1173 - 0151

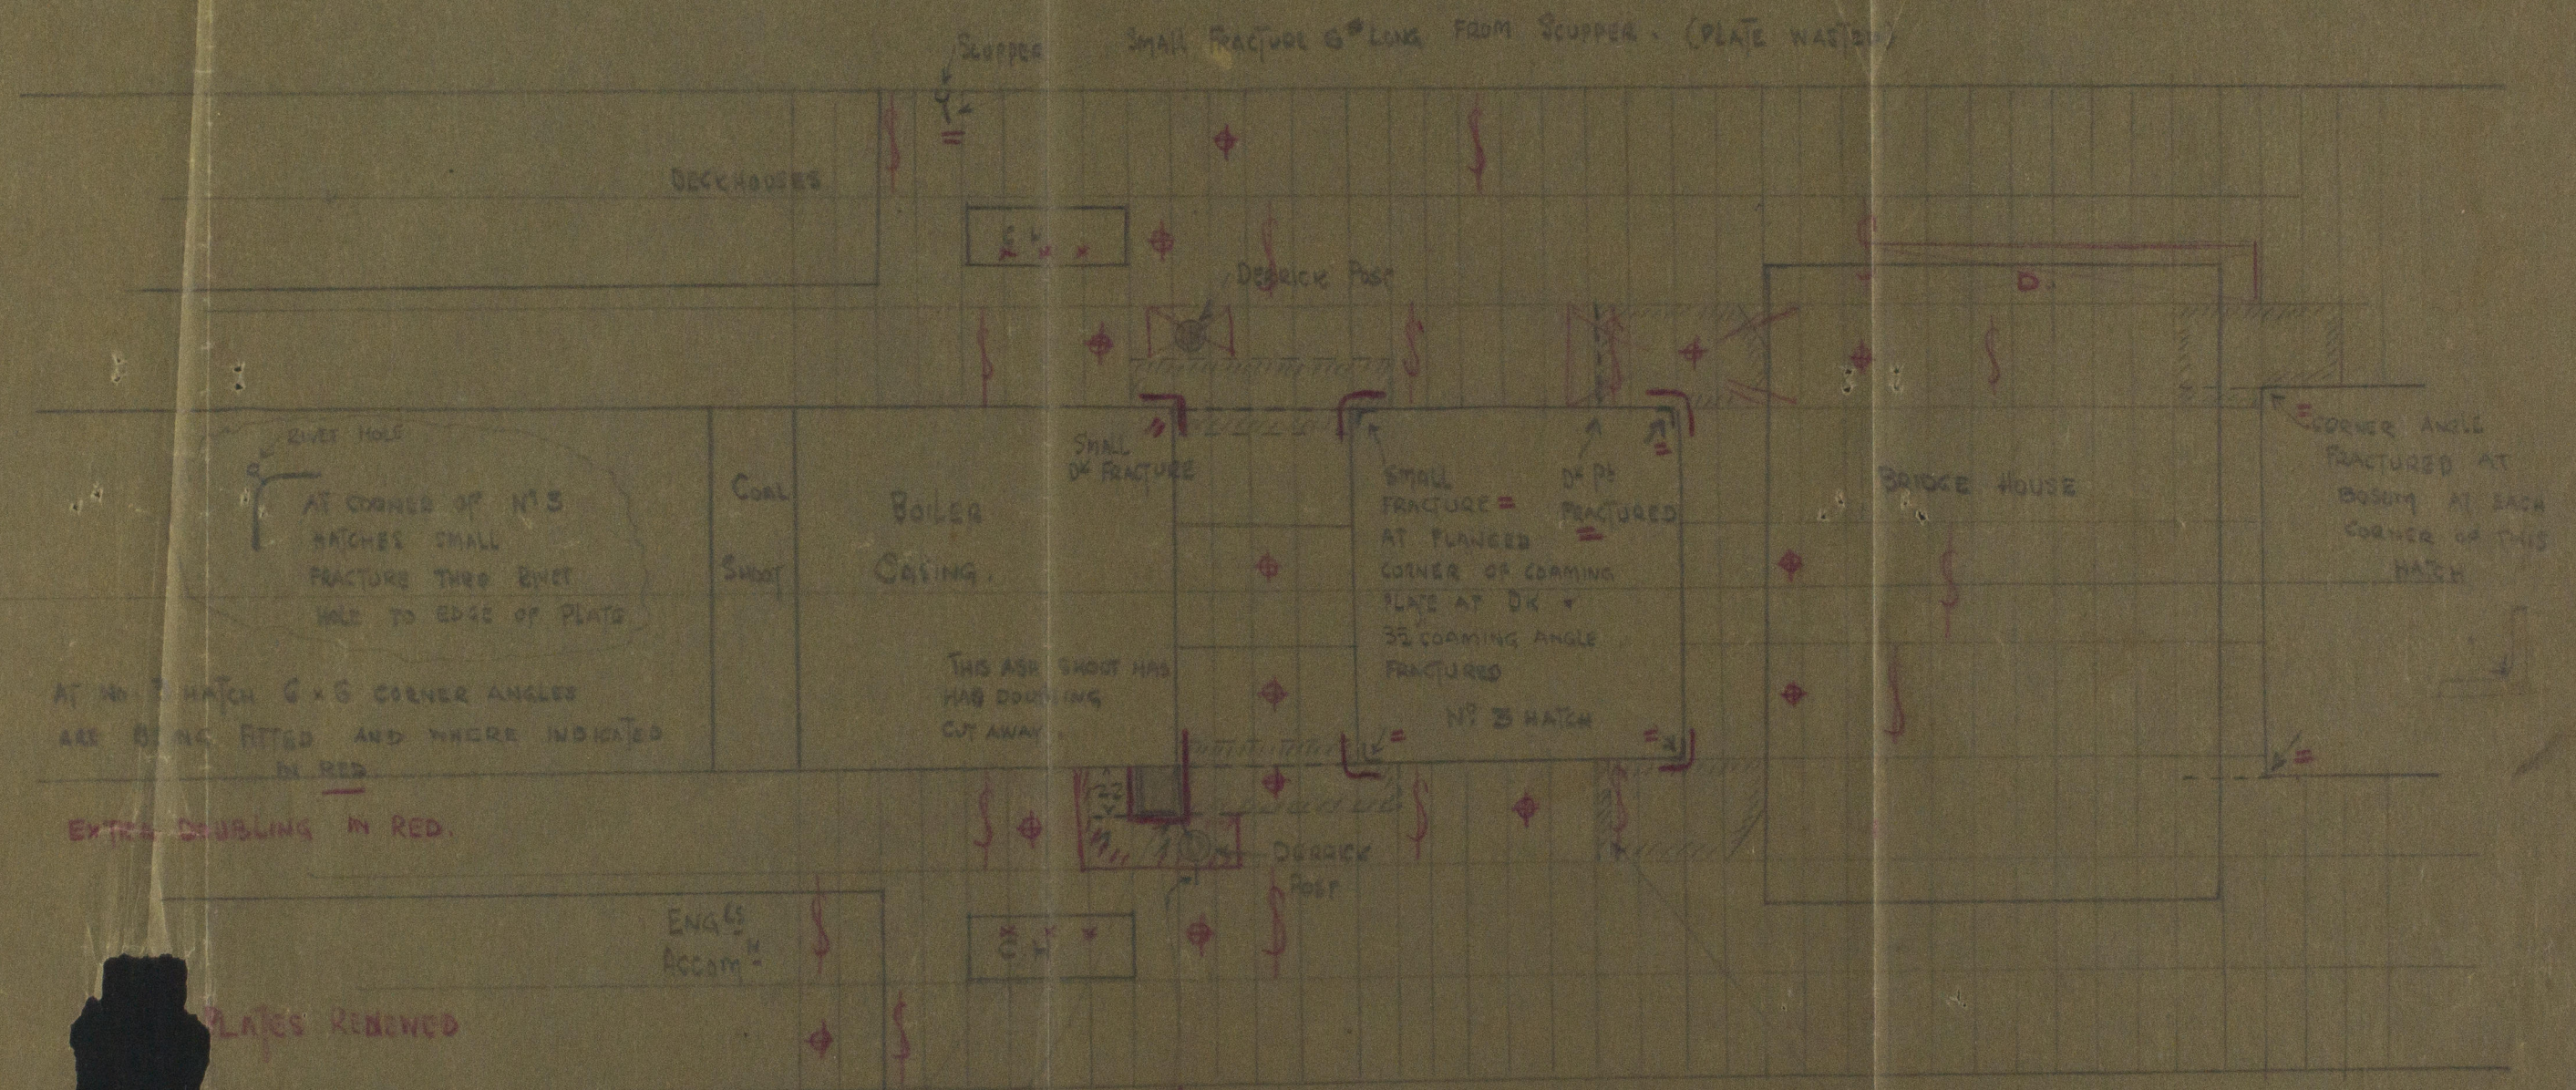
PLATES IN DK HOUSE
REMOVED FOR WASTAGE

RIVET HOLE
AT CORNER OF NO 3
HATCHES SMALL
FRACTURE TWO RIVET
HOLE TO EDGE OF PLATE

AT NO 3 HATCH 6x6 CORNER ANGLES
ARE BEING FITTED AND WHERE INDICATED
IN RED

THIS ASH SHOOT HAS
HAB DOUBLING
CUT AWAY

SMALL
FRACTURE =
AT PLANGED
CORNER OF COAMING
PLATE AT DK +
35 COAMING ANGLE
FRACTURED

CORNER ANGLE
FRACTURED AT
BOSOM AT EACH
CORNER OF THIS
HATCH

PLATES REMOVED

THIS BRACKET WAS
WASTED AWAY AT ASH SHOOT AND IN EFFECTIVE.

102
FRACTURE FROM CORNER OF
ASH SHOOT OPENING TO DERRICK
POST AND ACROSS PLATE TO 6" INTO
ADJOINING STRAKE. FRACTURE TWO
RIVET HOLES IN DECK RING (28" DIA)

BEAM AT 102 WASTED AWAY AT ASH SHOOT.

THIS PLATE HAS
FRACTURES ON SHELTER DK
HAD A DOUBLING
FITTED COVERING
PREVIOUS FRACTURE

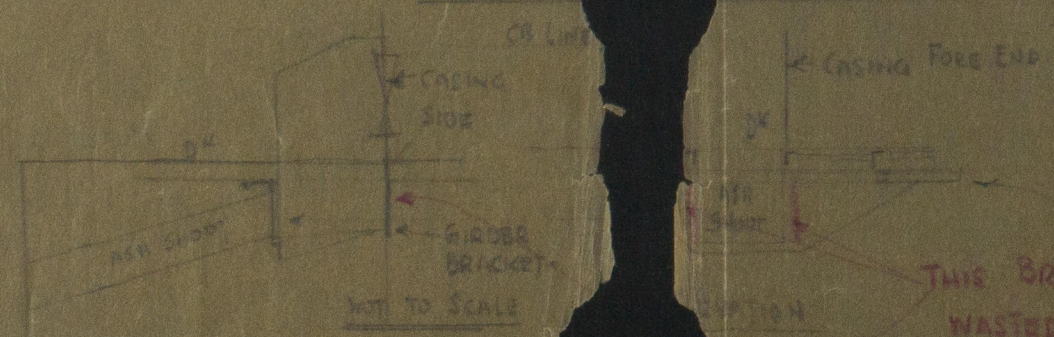
EXTRA DOUBLING IN RED.
